Access Compliance Report

Public Rights-of-Way

Intersection ID: 29460	Main Street: N_ALEXANDER_ST	Cross Street: GARDEN_DISTRICT_DR	Location: E
ADA ID: 24CEE04641D7	Ramp Type: PerpDiag	Initial Pass/Fail: Fail	Overall Compliance: No
		Severity Score: 10

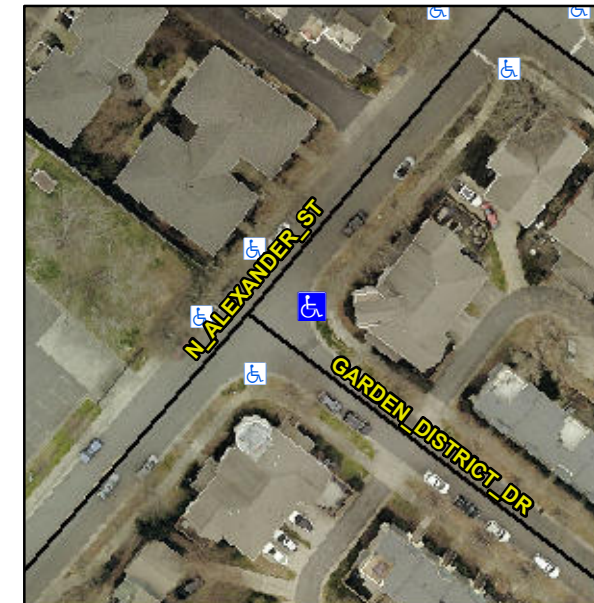
Not Found, R304.5.1, R304.5.3

Compliance	Description	Data	Compliance	Description	Data
N/A	Ramp Length (in)	71.0	Yes	Ramp Slope (%)	5.4
No	Ramp Width (in)	45.0	No	Ramp XSlope (%)	5.0
N/A	Flare Type LT	N/A	N/A	Flare Type RT	N/A
N/A	Flare Slope LT (%)	N/A	N/A	Flare Slope RT (%)	N/A
N/A	Flare Traversable LT?	N/A	N/A	Flare Traversable RT?	N/A
N/A	Landing Length (in)	N/A	N/A	DWS Provided?	N/A
N/A	Landing Width (in)	N/A	N/A	DWS Contrast?	N/A
N/A	Landing Slope (%)	N/A	N/A	DWS Length (in)	N/A
N/A	Landing X Slope (%)	N/A	N/A	DWS Full Width?	N/A
N/A	Landing Curb? (Y/N)	N/A	N/A	DWS Offset (in)	N/A
N/A	Shared Landing?	N/A			
N/A	Gutter Ponding?	N/A	N/A	Gutter Slope (%)	N/A
N/A	Gutter Lip Ht (in)	N/A	N/A	Gutter X Slope (%)	N/A
N/A	Painted X Walk1?	No	N/A	Painted X Walk2?	No
	X Walk 1 Direction	To NW		X Walk 2 Direction	To SW
N/A	X Walk 1 Width (in)	N/A	N/A	X Walk 2 Width (in)	N/A
	X Walk 1 Slope (%)	0.5		X Walk 2 Slope (%)	4.6
	X Walk 1 X Slope (%)	7.4		X Walk 2 X Slope (%)	1.3

Remove & Replace Curb Ramp With Two New Directional Ramps or Equivalent.
